SUBJECT: Transmittal Memorandum for EHB-9 Issuance 02-05

Engineering Handbook No. 9 (EHB-9), Automatic Radiotheodolite (ART - 1/2), Section 3.4, Modification Note 18, 10.7 Megahertz (MHz) Test Point R/ACU Test Panel Rewiring.

ART MODIFICATION NOTE 18 (for Electronics Technicians)

SUBJECT : 10.7 Megahertz (MHz) Test Point R/ACU Test Panel Rewiring

**Figure 1****Figure 2****Figure 3****Figure 4**

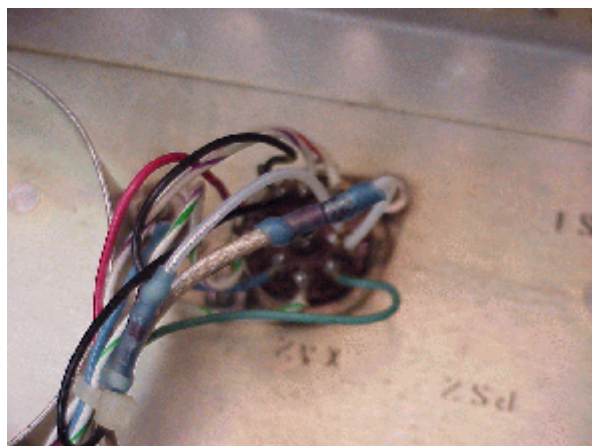
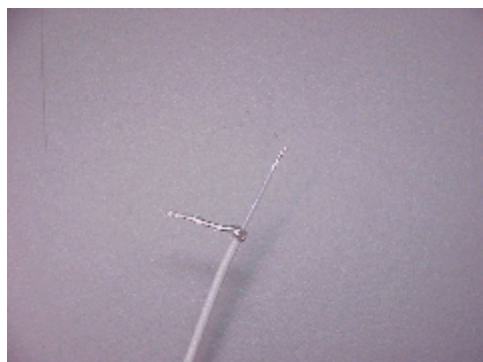
7. Carefully unsolder the white lead from the "10.7 MHz" test point (figure 1).
8. Disconnect the other end of the white wire attached to XA2-1 (figure 2).
9. Remove the black (ground) wire from the "SIG GND" test point (figure 1).
10. Locate the Belden cable #83284 in the modification kit and carefully separate the ground shield from the center conductor (figure 3).
11. Take the black wire unsoldered in step 9 and twist it together with the ground shield of the Belden cable.
12. Solder both wires to "SIG GND" test point (figure 4).
13. Take the center conductor of the new Belden Cable #83284 and solder it to the 10.7 MHz test point (figure 4).
14. Remove the self-tap screws, flip the test panel over, and slide it back into slot A1.
15. Using the self-tap screws, secure the panel to the card cage.
16. Route the new Belden cable under the test panel and between PS2 to the A7 board.

Figure 5

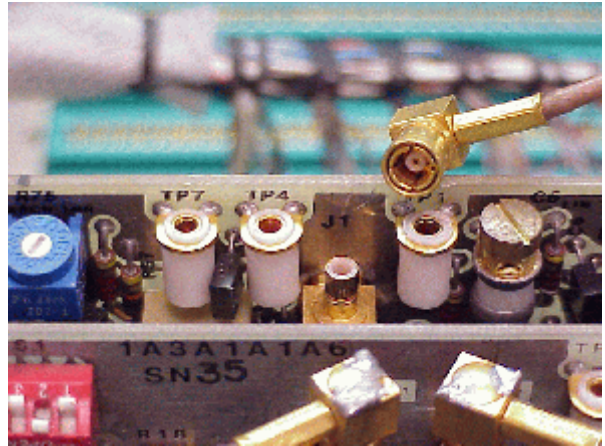
17. On the A7 board, disconnect the 10.7 MHz IF cable from J1 (figure 5).
18. Connect the PE9302 tee adapter  to the PE9118 plug  then to J1 on the A7 board (figure 6).
19. Connect the 10.7 MHz IF cable, removed in step 17, to the PE9302 tee adapter.
20. Connect the other end of the Belden cable W/PE4046 connector  to the PE9302 tee adapter.
21. Using 2 people, lift the drawer up onto the R/ACU housing assembly slide rails and reconnect the cables to the back of the drawer.
22. Slide the drawer back into the housing assembly.
23. At the front of the drawer, turn the power switch to the ON position.
24. Use the necessary test equipment and verify that all signals labeled on the test panel are available.
